**Pier 40 Structural Restoration – Phase 3
Invitation for Bids (IFB)
Project/Contract #C4873
Addendum No. 1
January 3, 2019**

- 1. The above referenced IFB is hereby amended to include the Site Logistics Plan attached hereto as Attachment A.**
- 2. Sheet S502 (Concrete Repair Schedule) of the Issued for Bid Drawings in the above referenced IFB is hereby deleted in its entirety and replaced with Attachment B herein.**
- 3. All requirements of the original IFB shall remain in full force and effect, except as set forth in this Addendum and any other previously issued Addenda.**
- 4. All capitalized terms set forth in this Addendum shall have the same meaning as set forth in the IFB being amended hereby.**

AMENDED AND RESTATED SHEET S502 – CONCRETE REPAIR SCHEDULE

C4873 and C4874 Logistics Plan

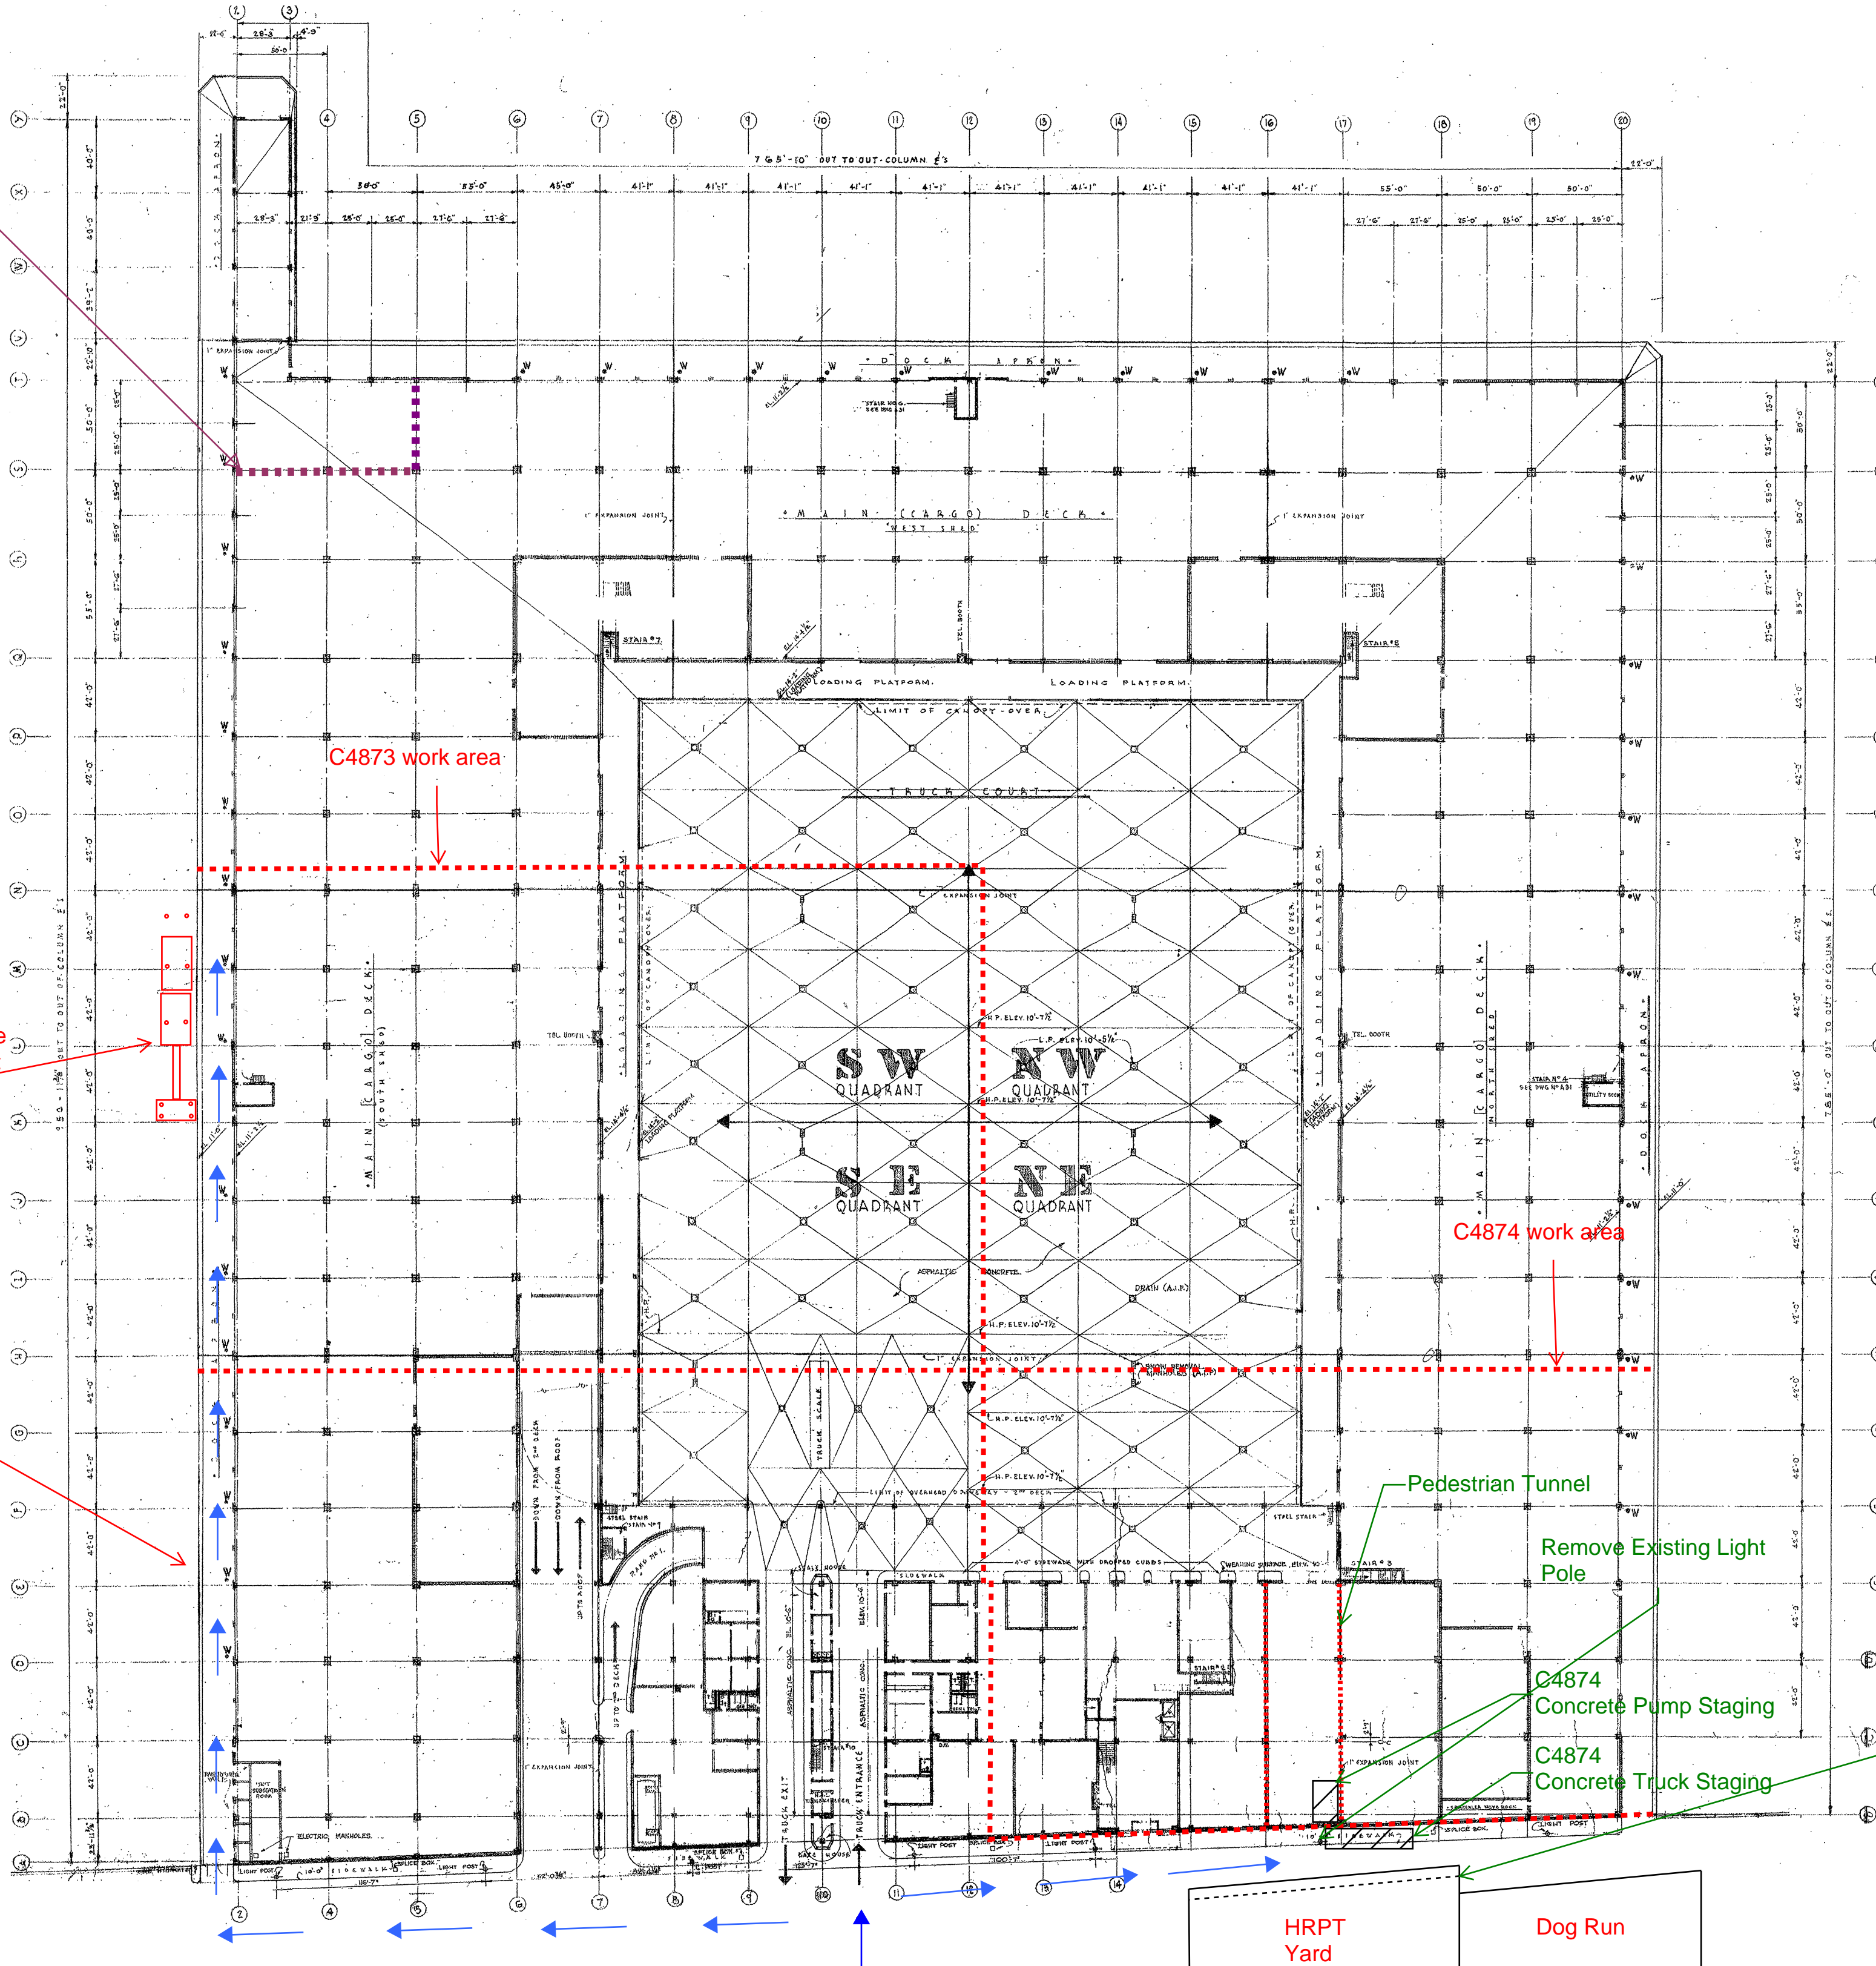
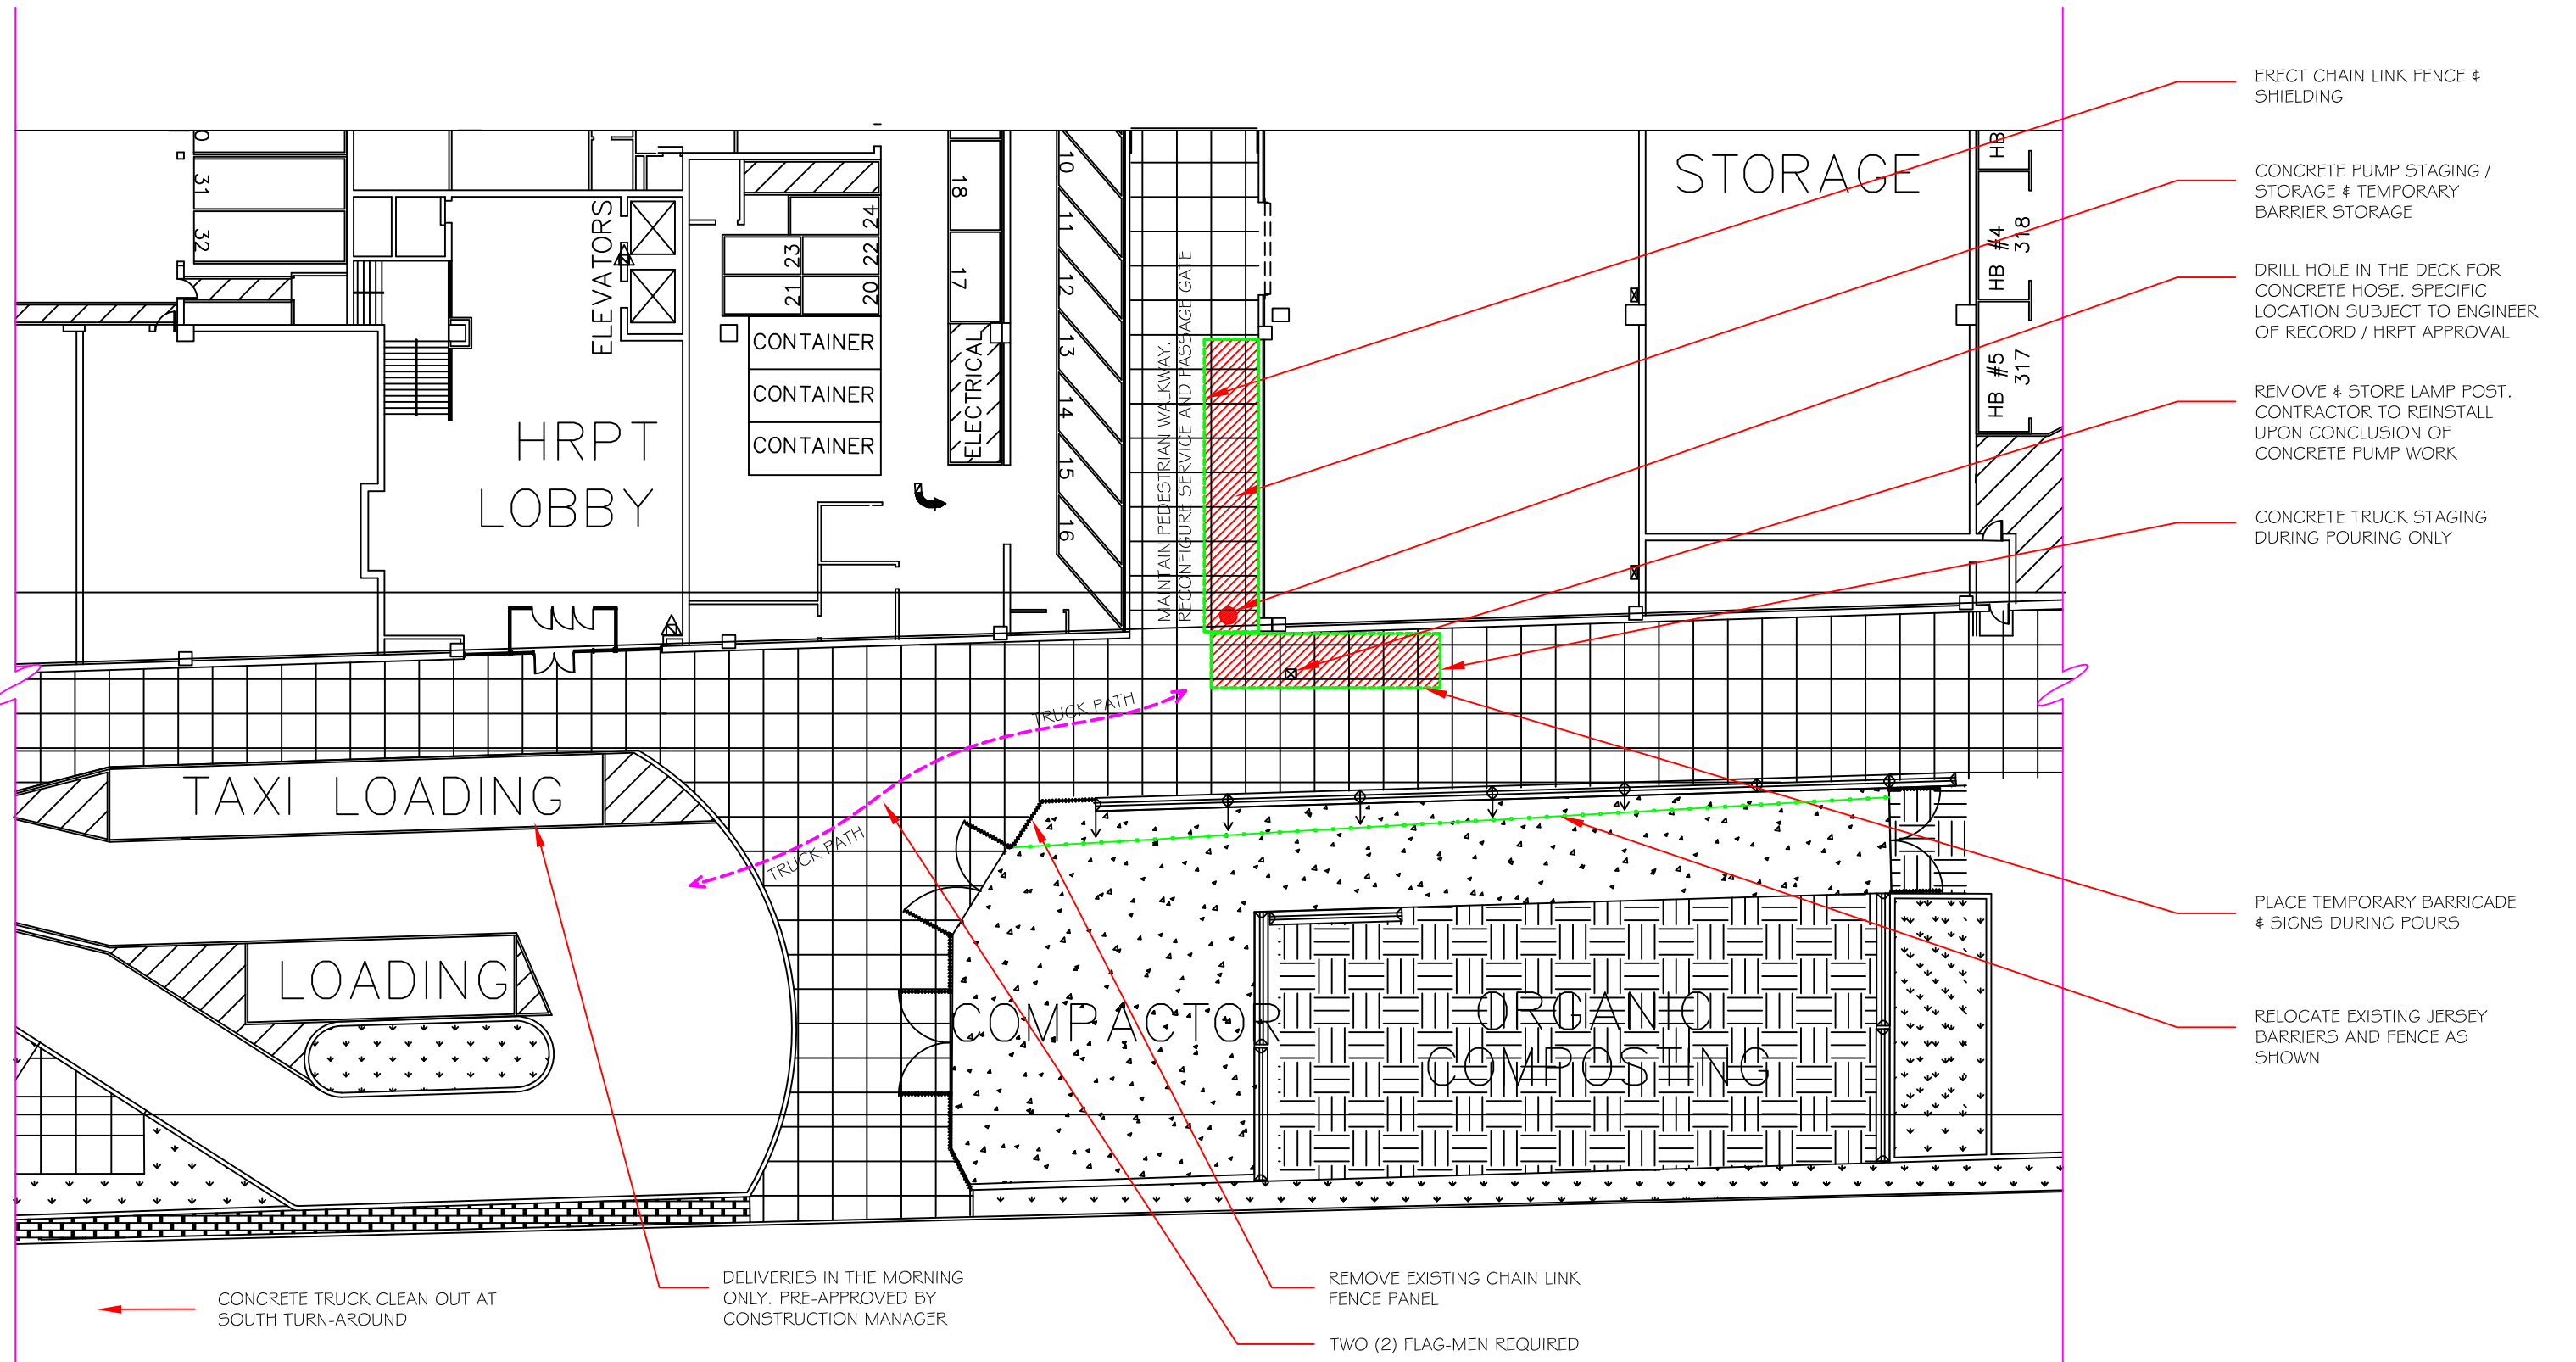
Install temporary fencing and gate under C4873 contract. This shared (C4873 & C4874) staging area is to be used for a construction trailers, etc

The concrete trucks and other construction vehicles can only travel on the pier and in front of the building when accompanied by two flagmen (front and back)

In the event of temporary closure of any public spaces on the pier, such as during a concrete pour, the contractor is responsible for set up and removal of detour barricades and signs.

North Pier apron will not be available for concrete pour staging (see Work Restrictions section of the project manual).

No dive equipment mobilization the pier aprons will be allowed. All staging is to be located on barges (see Work Restrictions section of the project manual)

C4874 concrete pump shall be set-up inside the pedestrian tunnel. C4874 discharging concrete trucks shall occupy a 11'x35' sidewalk area as shown. Maintain pedestrian access through the tunnel at all times during the concrete pour, inclusive of pedestrian shielding adjacent to the pump.

C4874 contractor will set up and remove temporary barricades and signs for pump and truck staging for each concrete pour day.

C4874 contractor is to relocate the jersey barrier, fence, and one gate approximately 5' east of the current location

Existing floating docks, ramp, and platform are to be removed by C4873 contractor, guide piles extracted. All salvaged materials relocated and reinstalled in the same configuration appropriately 240' east of the current location. The components to be removed and relocated are as follows:

1. 13.5'x7' timber platform
2. Two 30'x10' wood/plastic docks
3. 25'x3' aluminum ramp
4. Ten (10) 12" diameter (80' long) steel guide piles
